## YEAR 5 OF 5 MONITORING REPORT - FINAL

**Five-Mile Branch Stream and Wetland Restoration, Iredell County  
NCDMS IMS ID# 92185**

**Responses to Comments**  
**Draft Year 5 Monitoring Plan**  
**for**  
**Five Mile Branch Stream and Wetland Restoration Site**  
**NCDMS IMS ID # 92185**  
**DEQ Contract# 6036**  
**Comments and Responses**

**CURRENT CONDITION PLAN VIEW**

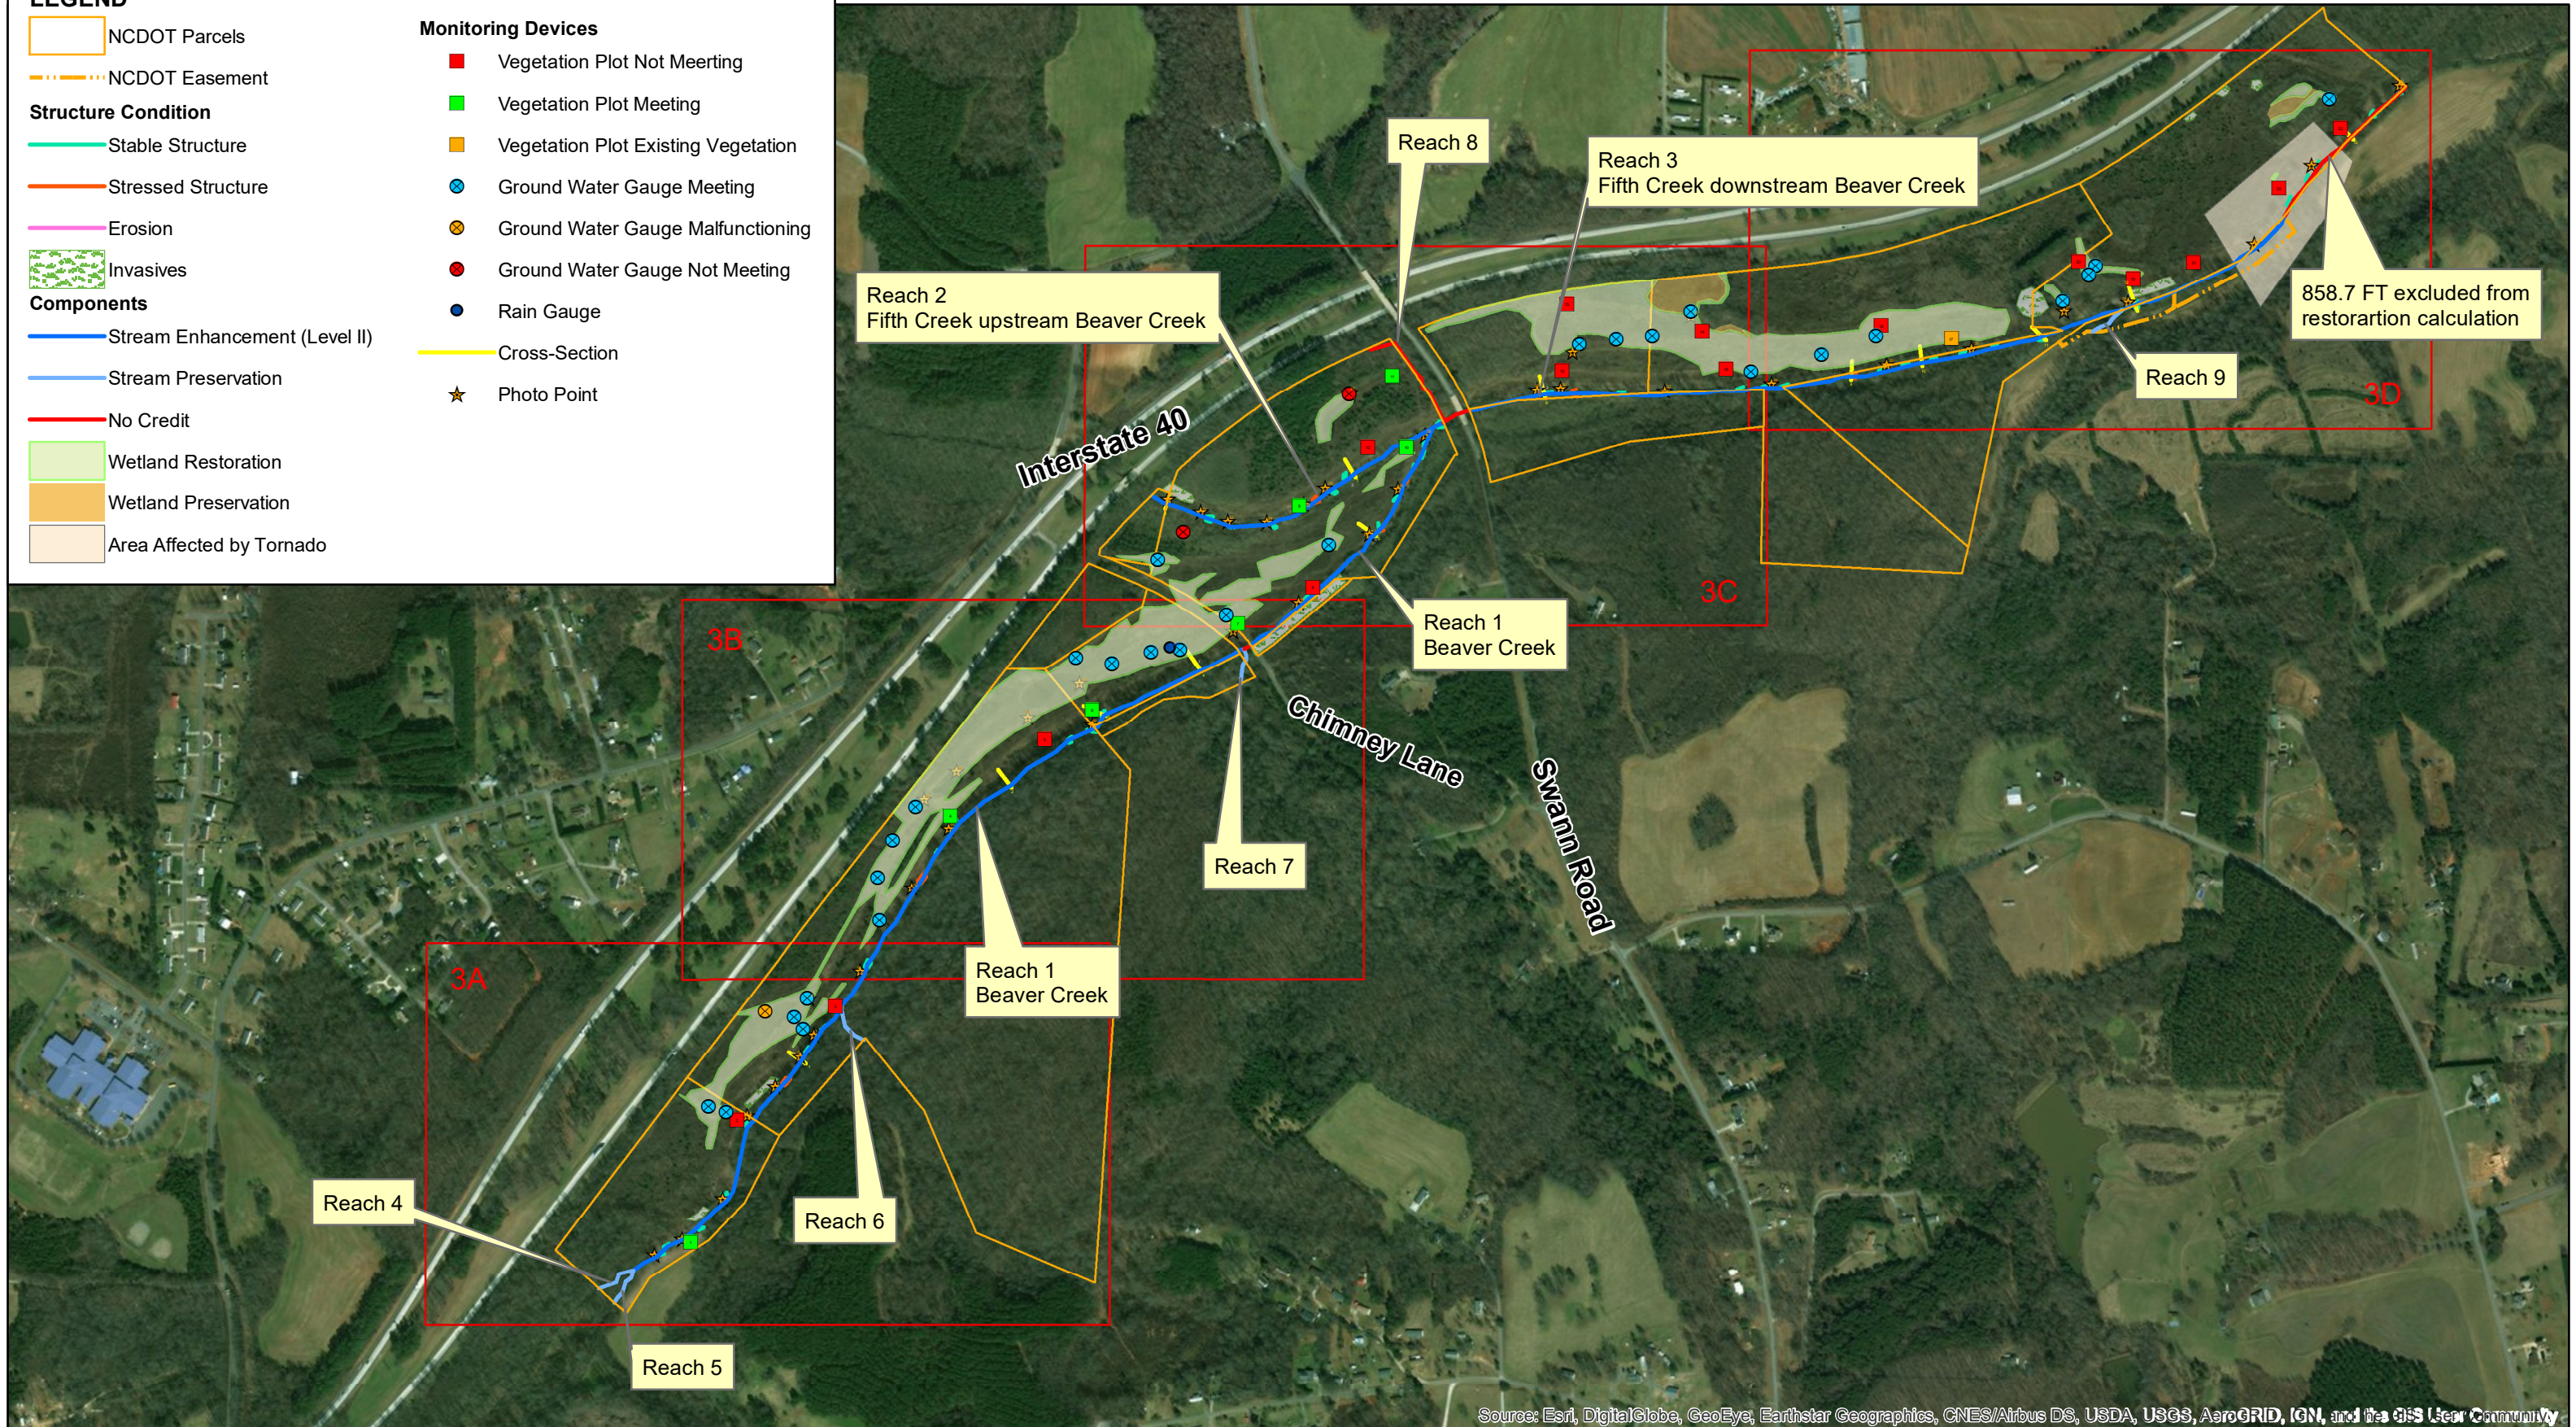
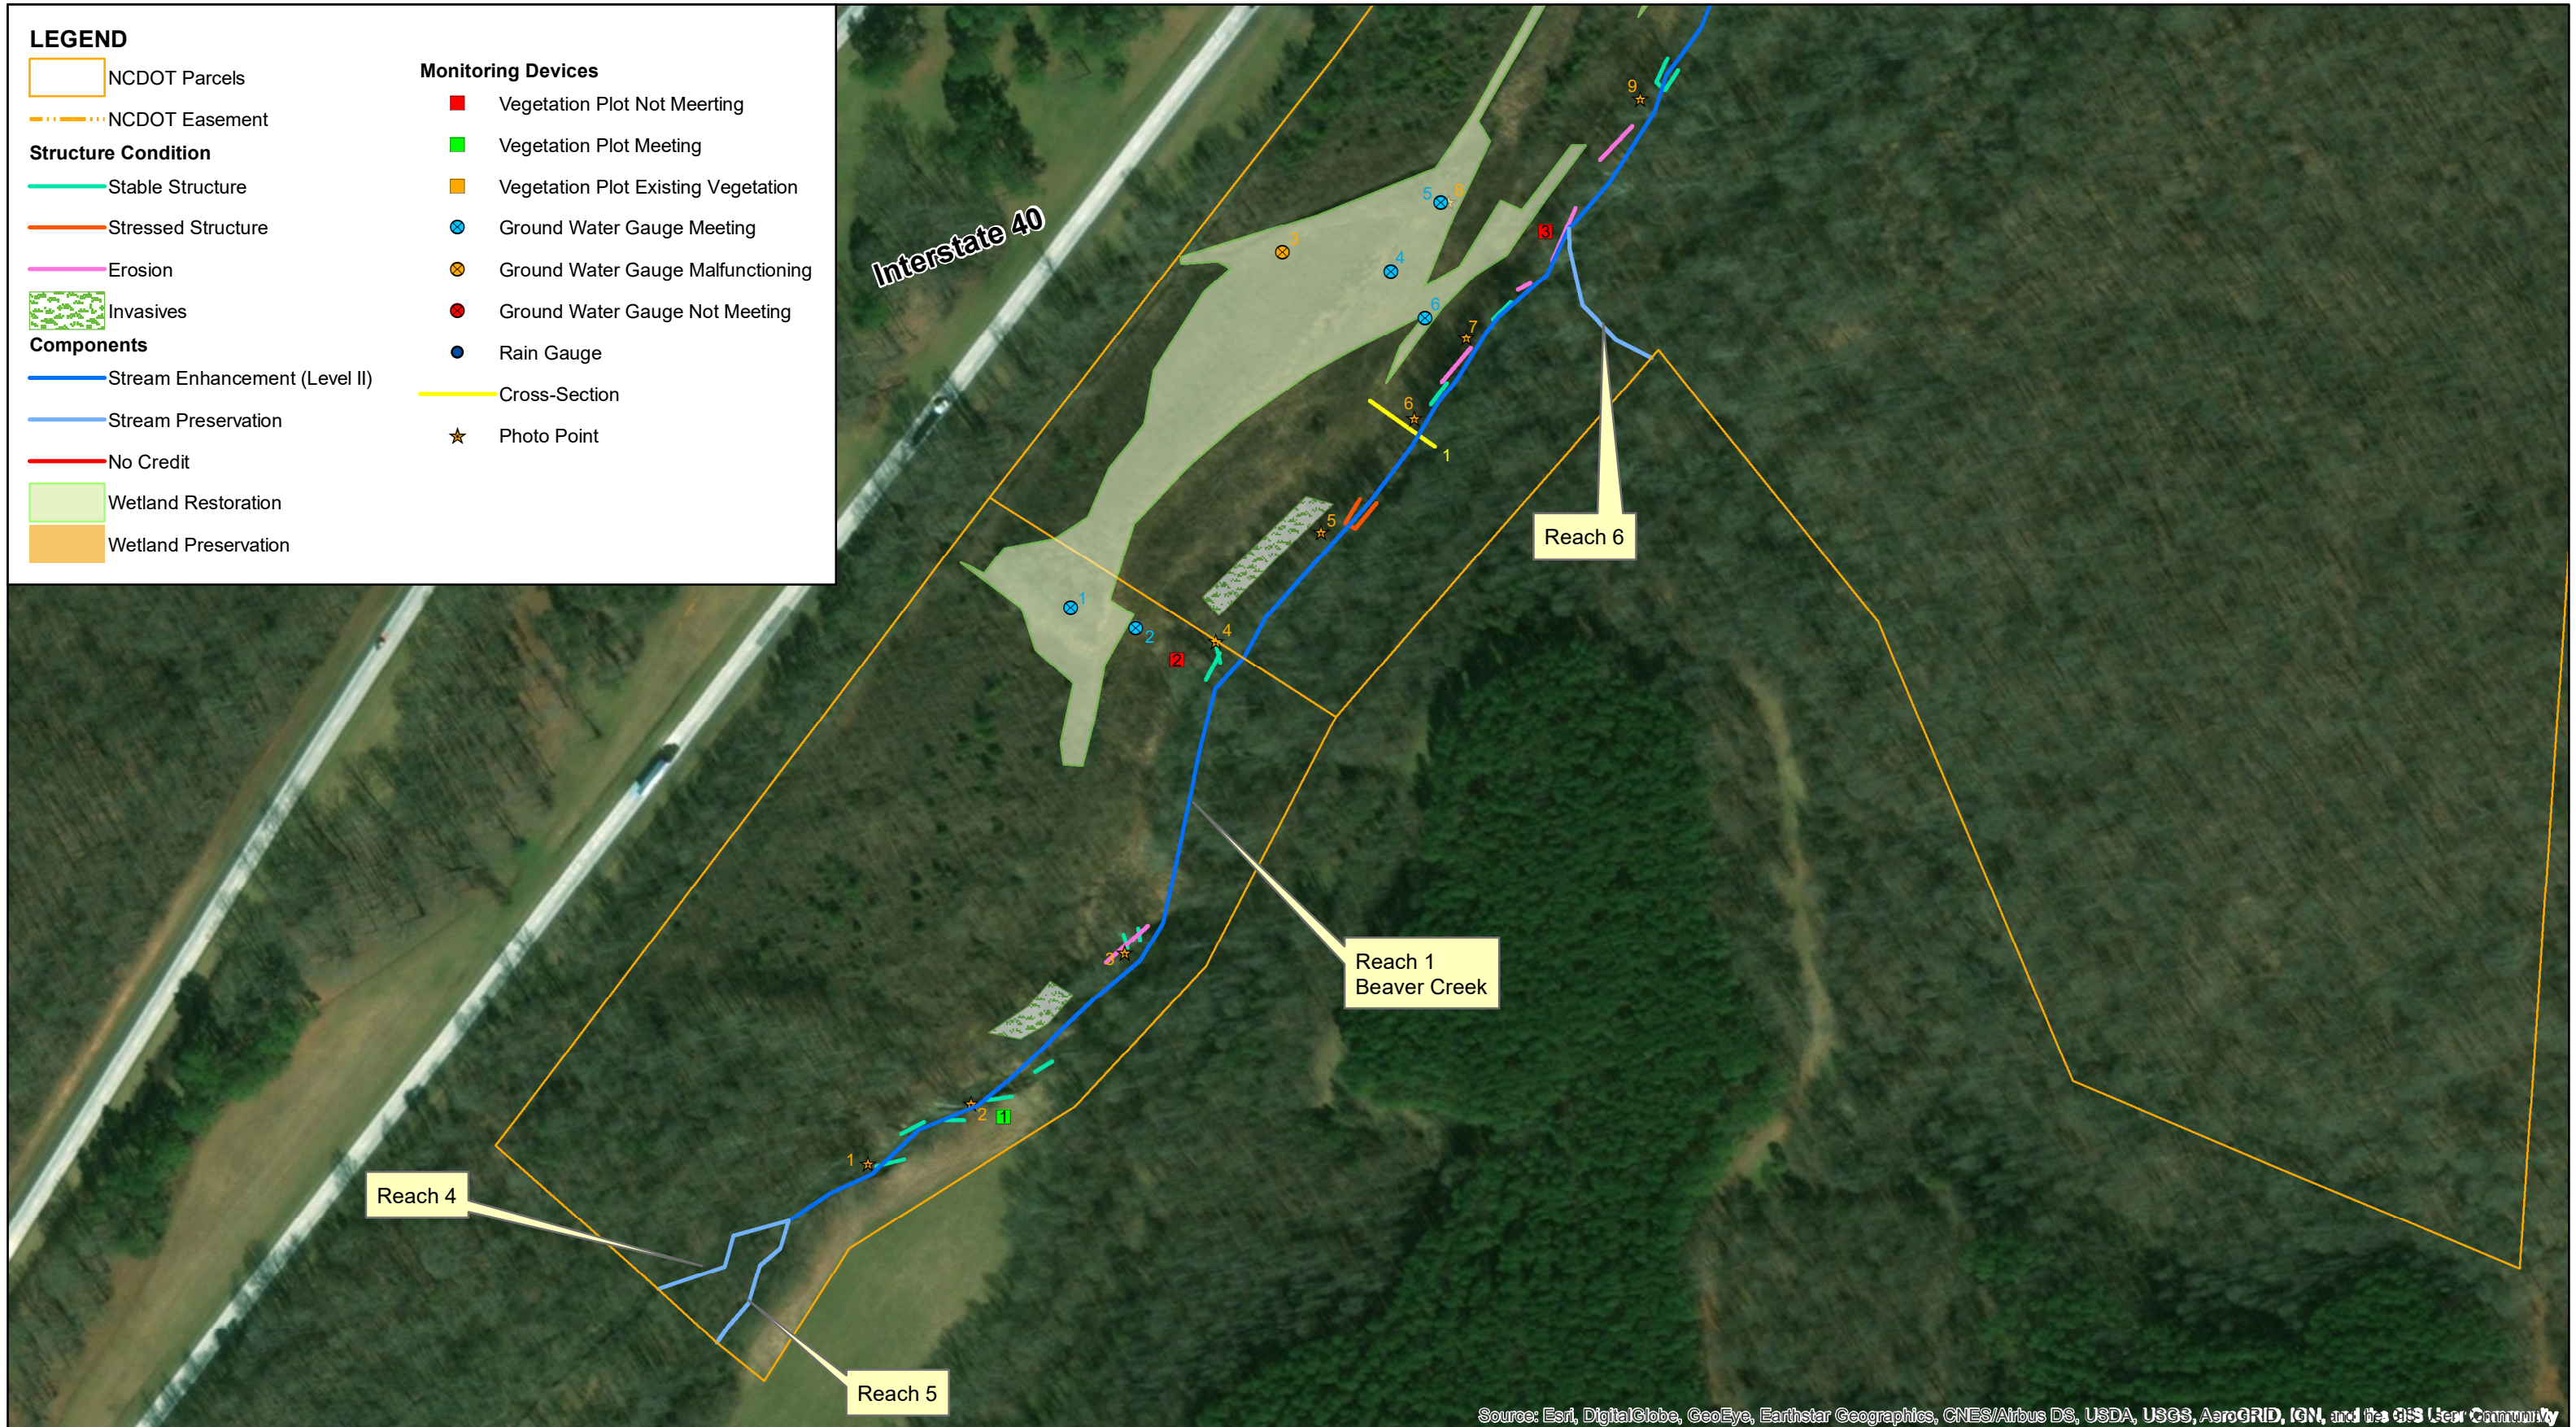
legend. Please terminate stream shapes that are located outside of the project boundary to avoid confusion about project credits.	
012	<b>CCPV Sheets:</b> Please remove the "Year 4 Wetland Delineation" label from the map legend. The project wetlands should be shown/ shaded as "Wetland Restoration" & "Wetland Preservation" with different colors to represent each approach on the maps and in the legends.	The CCPV Sheets were updated.
013	<b>CCPV Sheets:</b> Please include the preservation streams on the CCPV sheets. Please also provide stream names and mitigation approaches (EII; Pres) on the CCPV sheets.	The CCPV Sheets were updated.
014	<b>CCPV Sheets:</b> Please update the aerial to the most recent available.	The CCPV Sheets were updated.
015	<b>CCPV Sheets:</b> If mapped invasive areas have been treated and are dead, please removed them from the CCPV sheets. If updated on the CCPV sheets, please make sure to update Table 6 as well.	The CCPV Sheets were updated.
